REPORT TO DESIGN COMMISSION City of Sacramento

REVIEW AND COMMENT
August 18, 2010

Subject: **3820 Broadway (P10-042)** Located at the southeast corner of Broadway and Martin Luther King Jr, Boulevard, a request to develop a three story 56 unit residential tower with ground floor retail on 1.2+/- acres in the Broadway/Stockton and Oak Park Special Planning District (C-1-SPD) zone.

COURTYARD ELEVATION

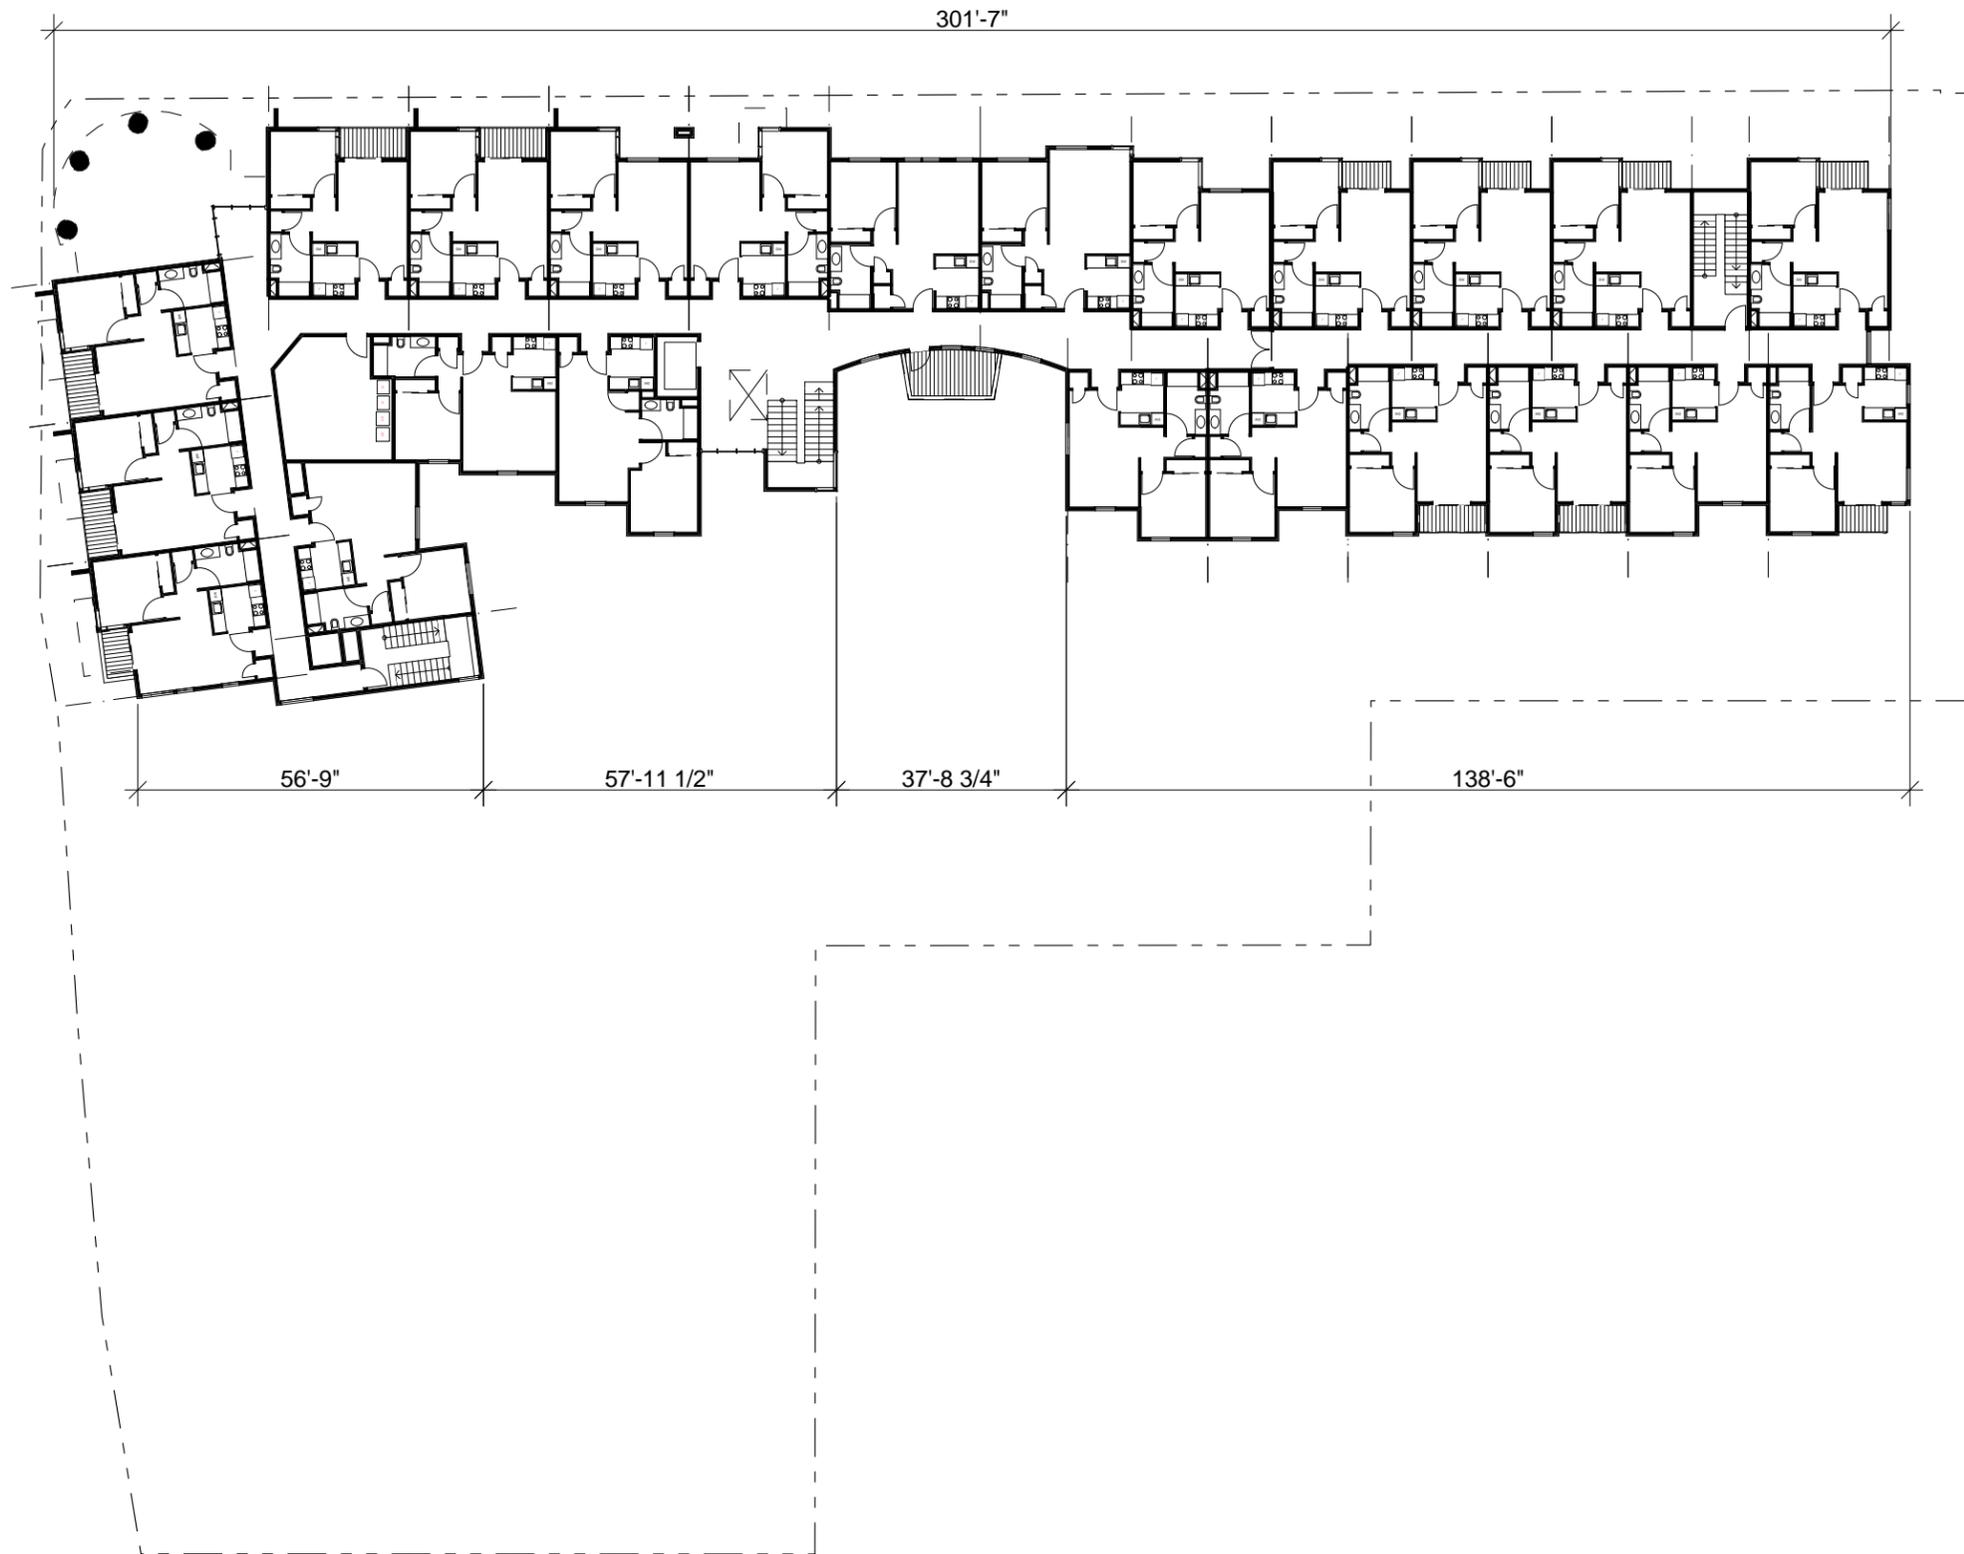
14. Staff recommends some additional color blocking at the Courtyard elevation at a few appropriate locations to further break up the monolithic appearance of the elevation. **Staff requests the Design Commission provide their recommendations regarding color blocking at this elevation.**

LANDSCAPE PLAN

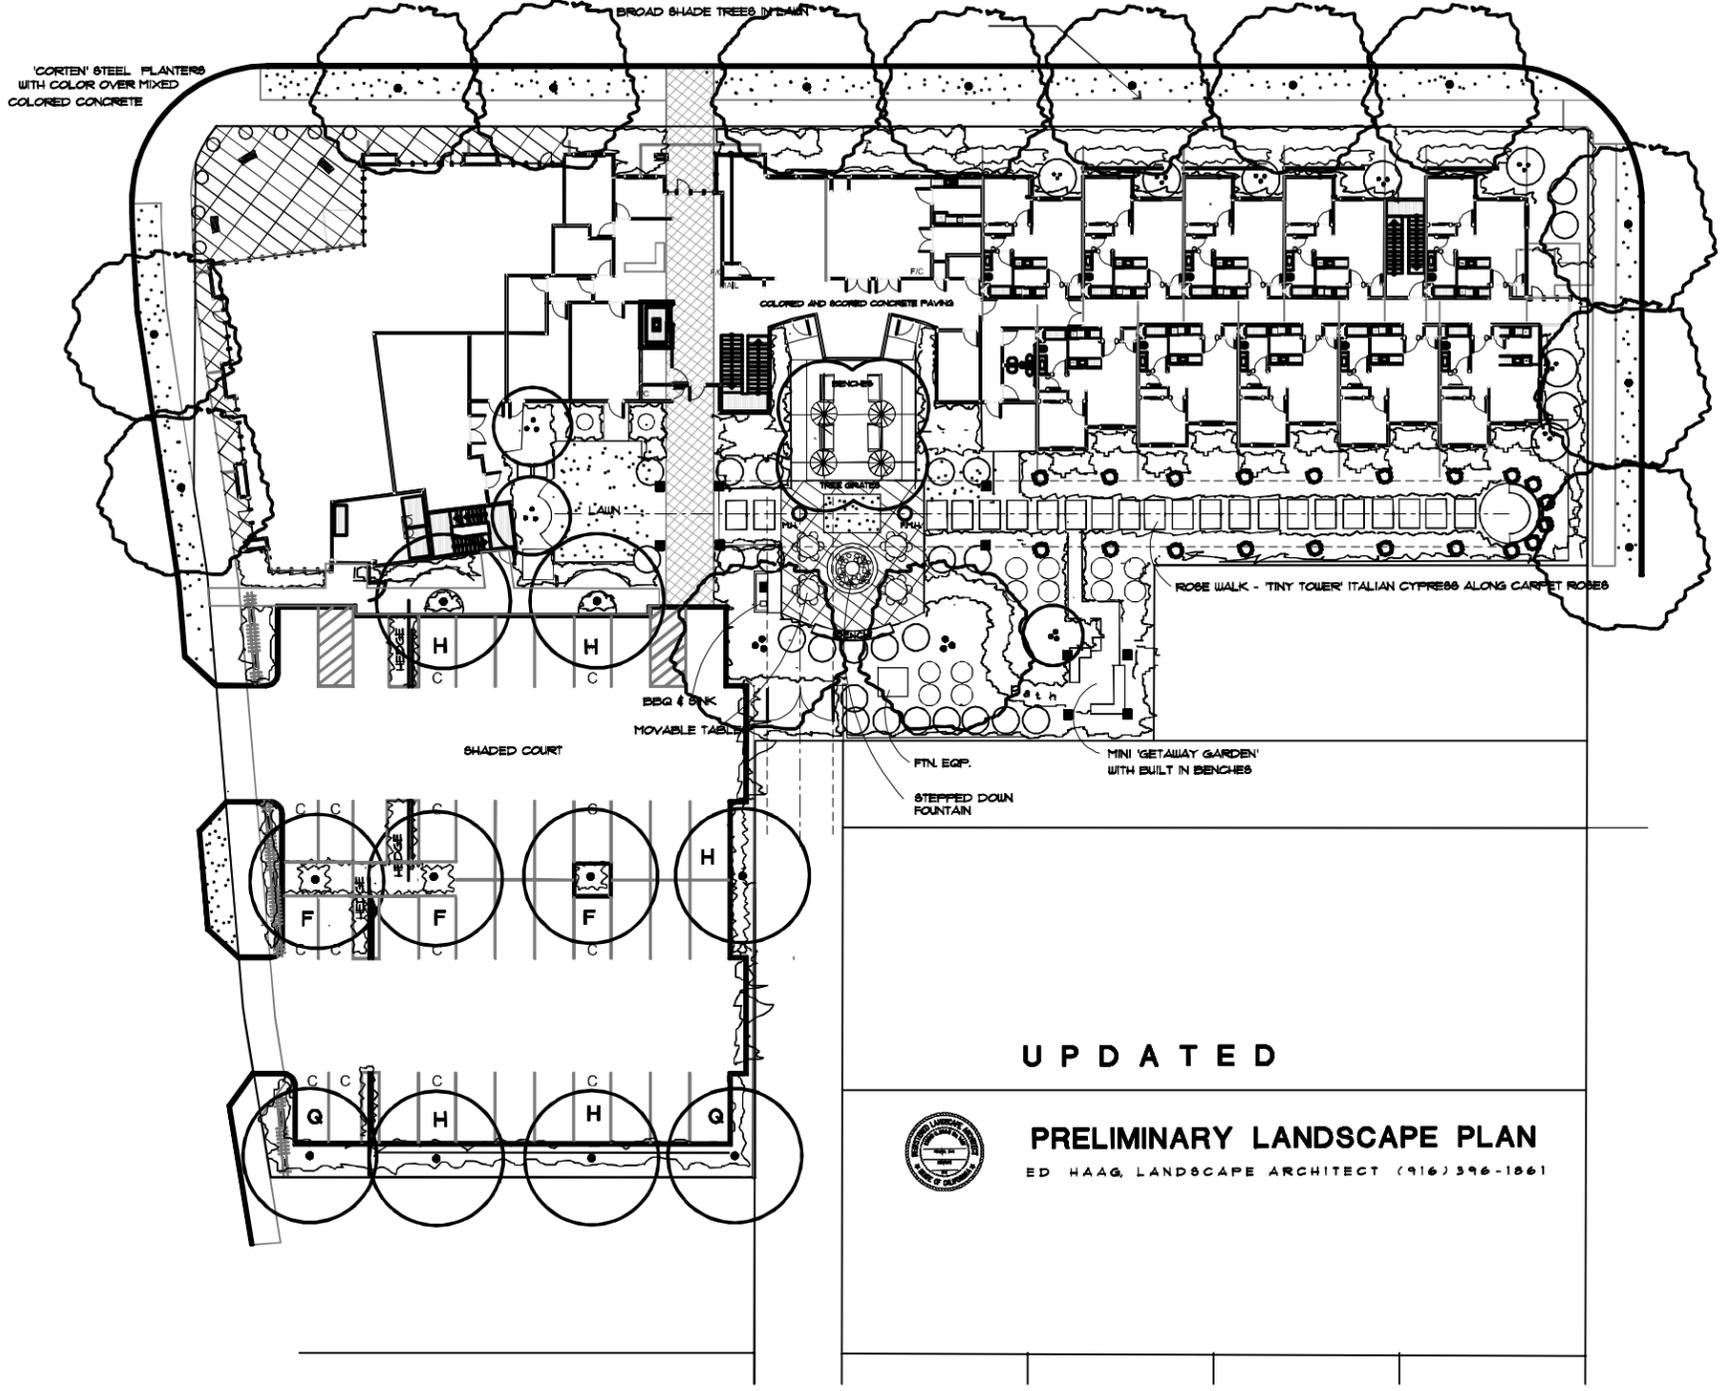
6. A substantial amount of landscaping has been provided on the proposed project. Staff supports the design provided, but recommends relocating the water feature north into the lawn area providing a better focal point for those walking down the Rose walk. Staff would like some additional detail or enlarged plans describing what type of materials and amenities will be provided in the rear landscape area provided at the review and comment hearing. Staff recommends that the barbeque area be relocated to the south of the water feature where the bench area is currently located, as this will provide an area that intentionally appears to activate the space and some additional screening of the proposed fountain equipment located to the south. **Staff recommends that the Design Commission comment on the adequacy of landscaping provided.**
